## APPROVED MINUTES OF THE MEETING

**September 4, 2008**

**4 September 2008****Light Rail Review Panel Review**

**Project:** University Link, UW Station and Pedestrian Bridge  
**Phase:** 60 Percent  
**Last Reviews:** August 16, 2007, September 20, 2007, December 6, 2007  
**Presenters:** Leo Berk, Artist  
 Ron Endlich, Sound Transit  
 Howard Fitzpatrick, Architect, LMN Architects  
 Barb Luecke, Arts Coordinator, Sound Transit  
 Barbara Swift, Landscape Architect, Swift Company

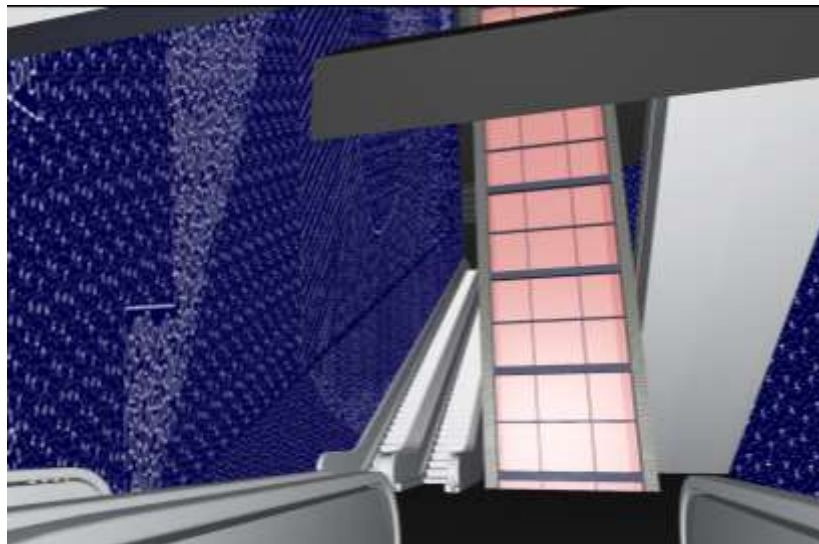
*The chamber ceiling doesn't meet the lower mezzanine level; is that a functional need?*

*Some concerns about balancing contemplative experience of dappled lighting, with safety lighting.*

*Potentially extraordinary moment inside architecture. Can potentially be the gem of all the stations. Ambivalent about shaping of chamber, but Leo's work is powerful.*

The proposed design is to have the chamber form to read as a sculptural object in the space, and to complete itself before it hits the ceiling.

There is a challenge to keep panel system backlit, while maintaining required light levels.

It seems doable to create lighting for safety, and accommodate the art.

### Site Structures

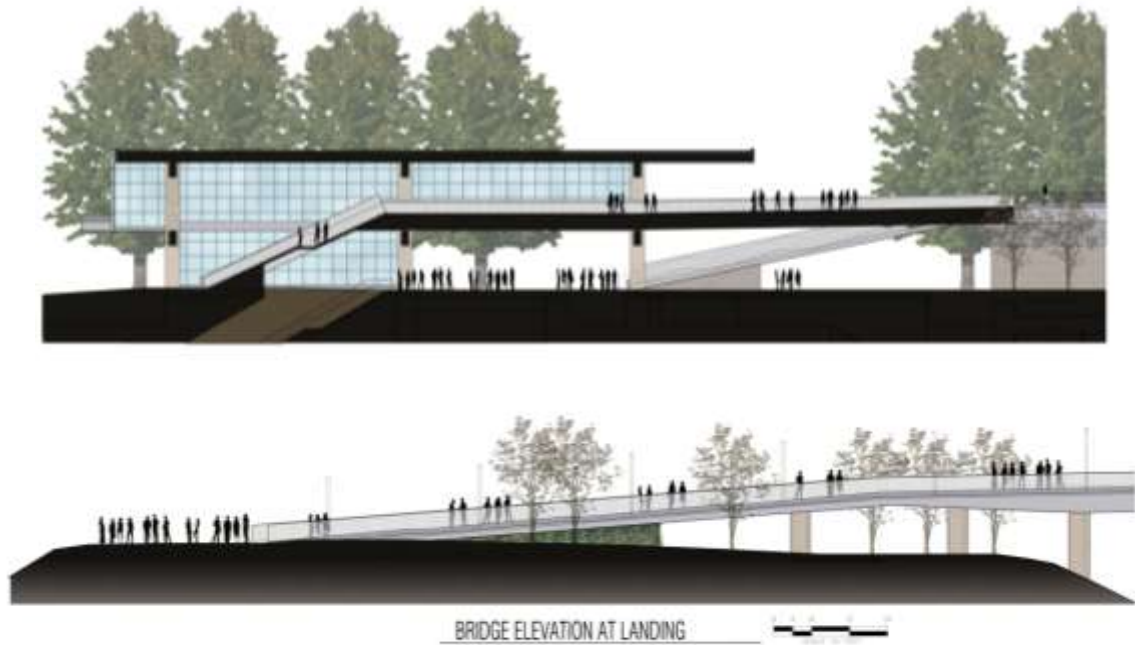
*Is the head house glass clear, reflective, or colored?*

*What will the head house look like at night?*

*There is concern that getting people to choose to use a sky bridge is very difficult, even when it could seem a rational choice; it would require an extraordinary and compelling design. The concept presented is utilitarian in both structural concept and expression.*

It is clear glass. We're working with the standard glazing system approved by Sound Transit.

It is illuminated from the ceiling, and will glow from within; although it is not designed to throw light outdoors.
